Subject: Response to the Referenced Information Request, Waste Isolation Pilot Plant
Hazardous Waste Facility Permit Number: NM4890139088-TSDF

Response to NMED Information Request, Determination of Class for a Permit Modification Request for the Excavation of a New Shaft and Associated Connecting Drifts

Figure A2-9c (with correction)
Underground Ventilation System Airflow (with S#5)

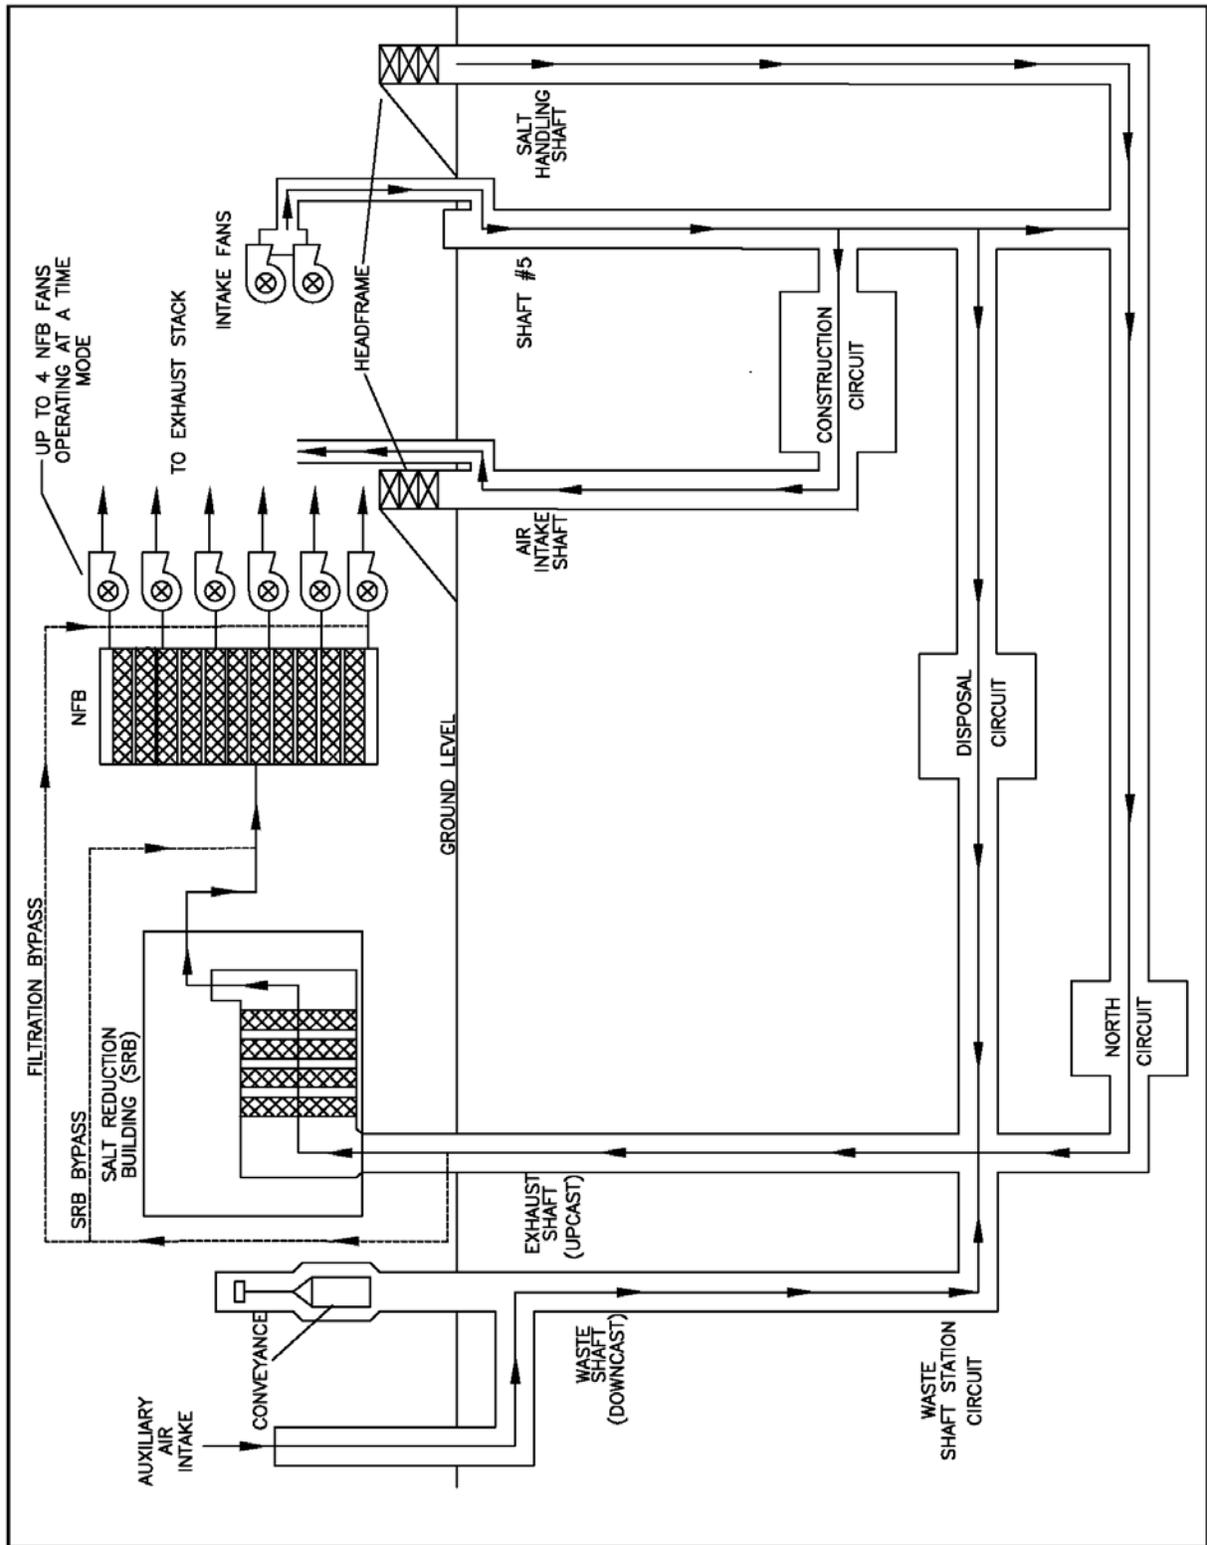
Identify any new Permit language that should be added, or any changes to Permit text that should be made, to the Class Determination since its submittal.

A change to the proposed Permit text that will be made is the correction of a “cut and paste” error in proposed Figure A2-9c, *Underground Ventilation System Airflow (with S#5)*. The corrected figure is attached to this document.
